**City of Charlottesville
Board of Architectural Review
Staff Summary
July 20, 2021**

Discussion of proposed stucco repairs

William Taylor Plaza – Phase I

(Currently the Fairfield Inn & Suites by Marriott Charlottesville Downtown/University Area)
401 Cherry Avenue

A-455

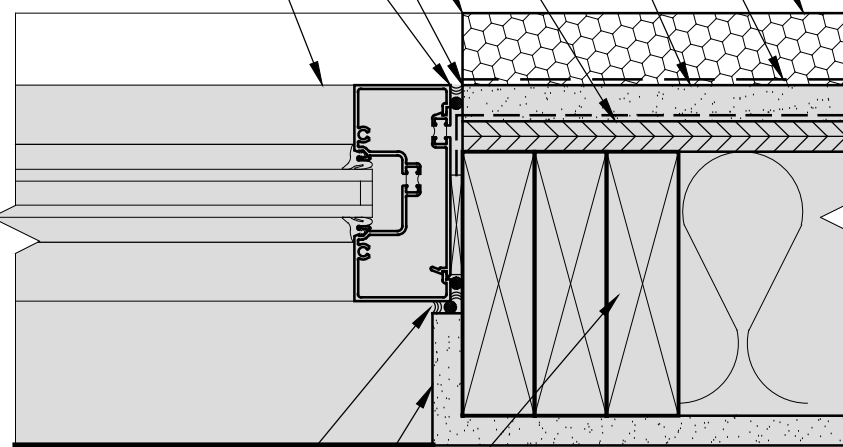
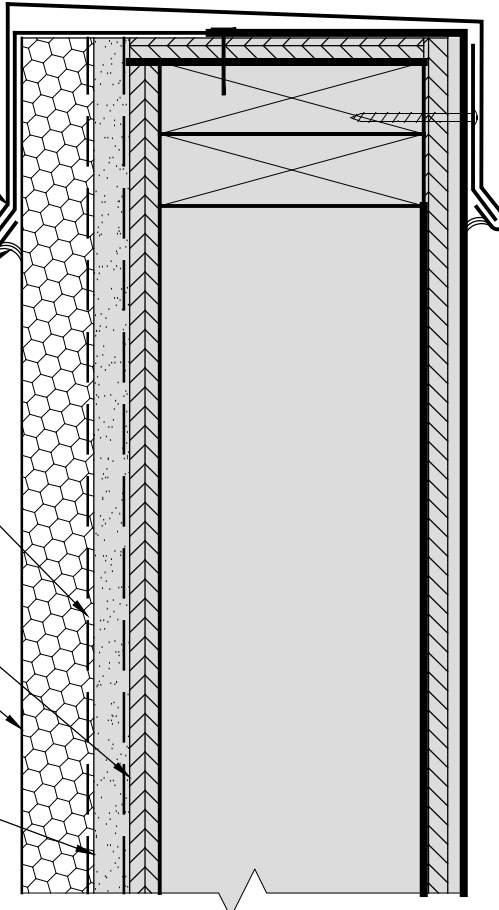
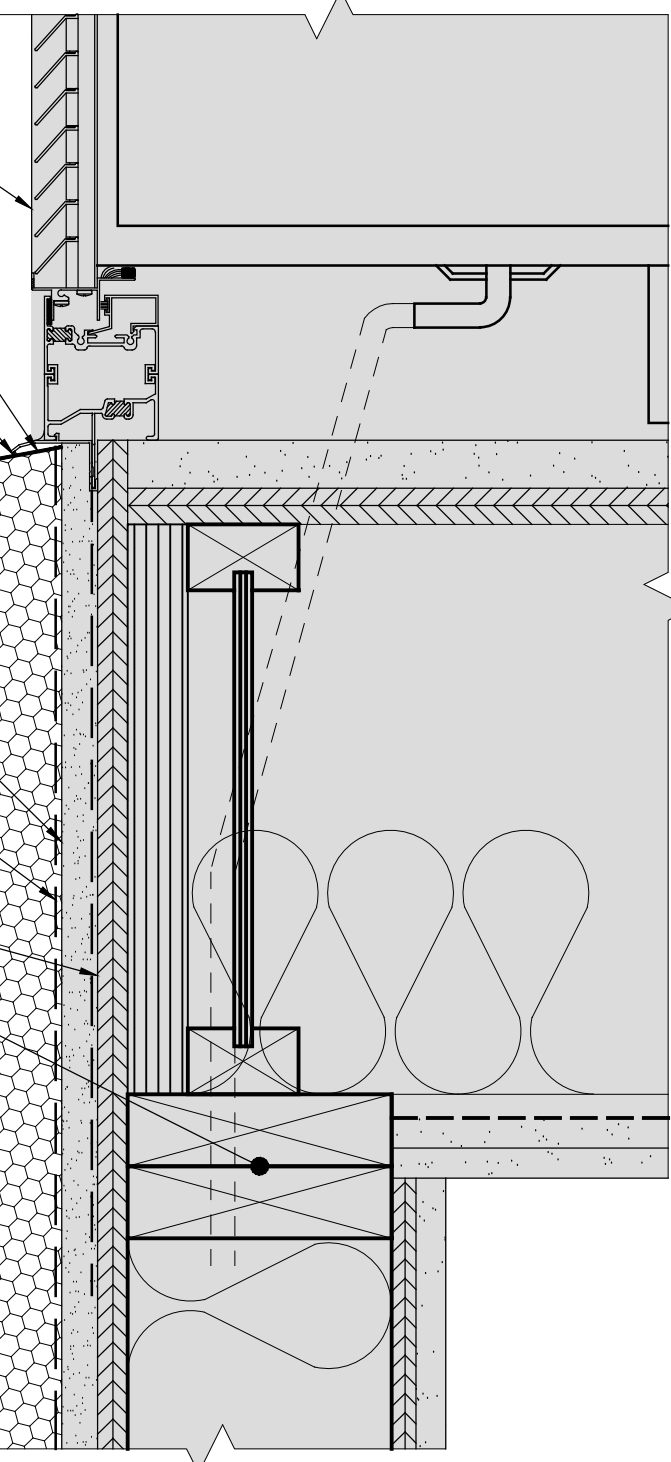
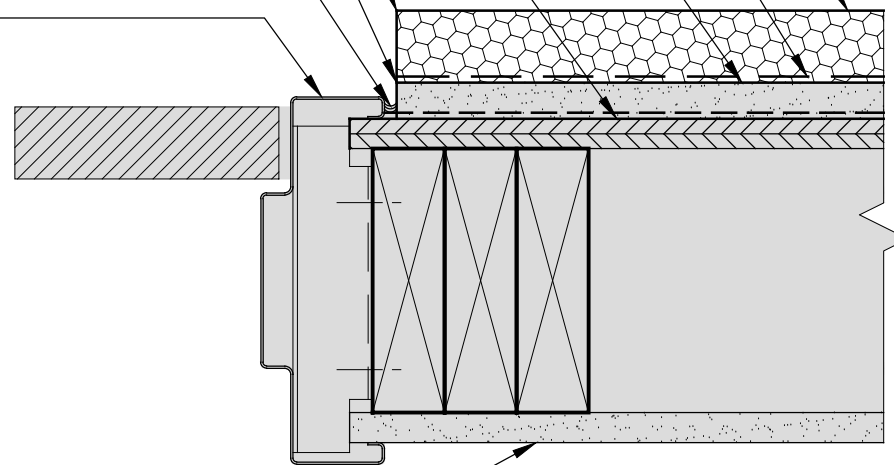
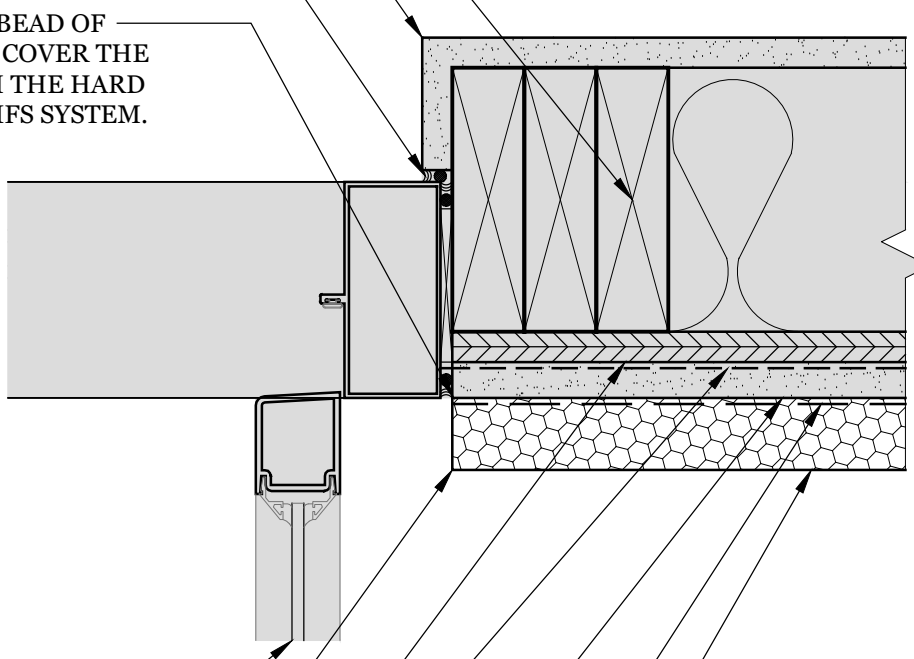
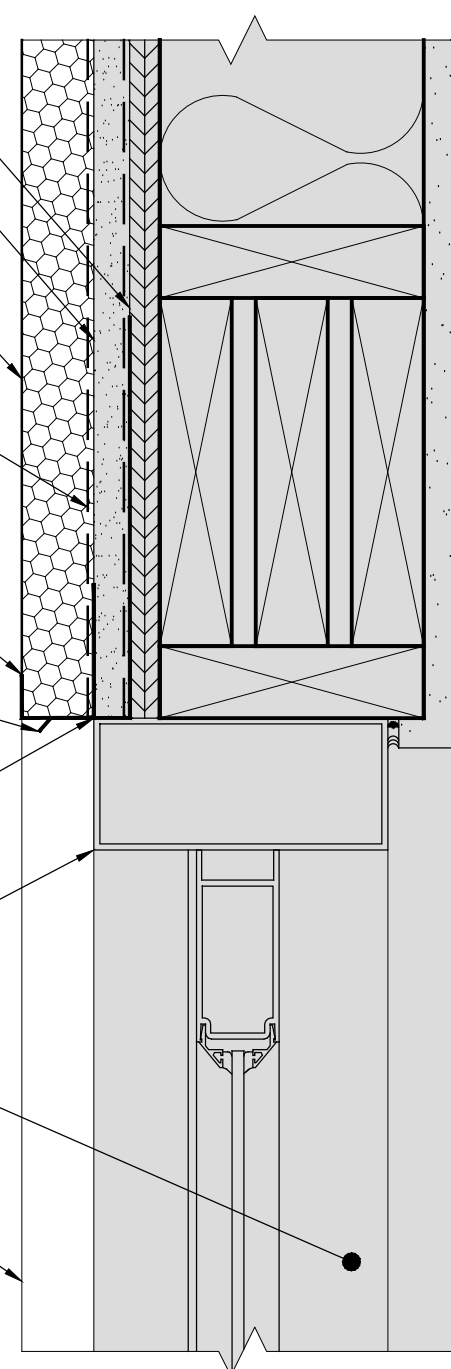
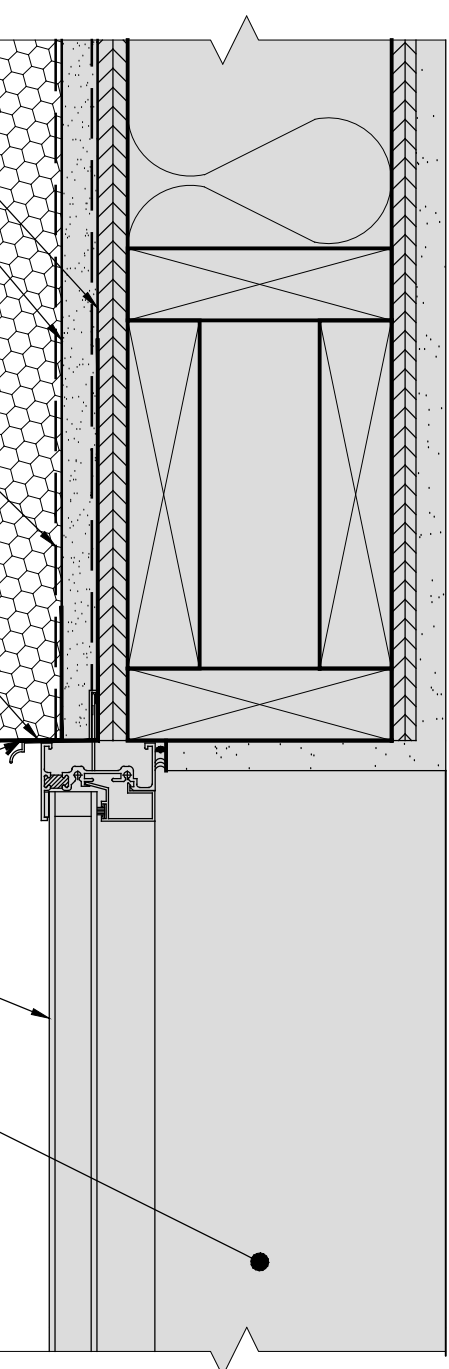
- Have they established where the moisture is coming from?
 - What exactly is the existing condition?
 - They refer to a vapor barrier. That does not appear to be indicated in the drawing.
 - What is the spec for that vapor barrier? Is it a vapor retarder (i.e. is somewhat permeable) or is it in fact a vapor barrier (i.e. impermeable)?
 - Is there a drainage plane associated with the vapor barrier?
- Request the manufacturer's specs & drawings for the proposed system – details as drawn are too generic.

The proposed repairs will apply a Parex EIFS system over the existing hard coat stucco. The primary details are shown on sheet A-455, which references to the existing hard coat stucco system (Decoplast Decowall FRS) and details how the Parex EIFS system will be installed (the water resistive and air barrier coating installed over the existing stucco). A-455 also illustrates the details at the various components—door and window trim and sills, roof parapet, etc.

Aside from the material and methods proposed for the repairs, the repairs will result in a slight reveal at the perimeter of the existing windows, doors, and vents. As built, the stucco is flush with these components—see the images below. This modification is detailed on Sheet A-455. This new detail will be consistent on the building—and, in fact, be similar to the reveal condition at the brick wall segments. Staff suggests this is an acceptable detail modification.

The roof coping—at the stucco sections and where they intersect with the other finishes—will be modified to accommodate the additional layer of stucco.

At the interior corners where stucco abuts either brick or siding, appropriate expansion joints and materials will be used to waterproof those locations.

The existing horizontal and vertical joints in the stucco will be replicated with the new surface; however, the new material will cover the existing joints, with the new joints only in that new layer of stucco, and not extending into the old.
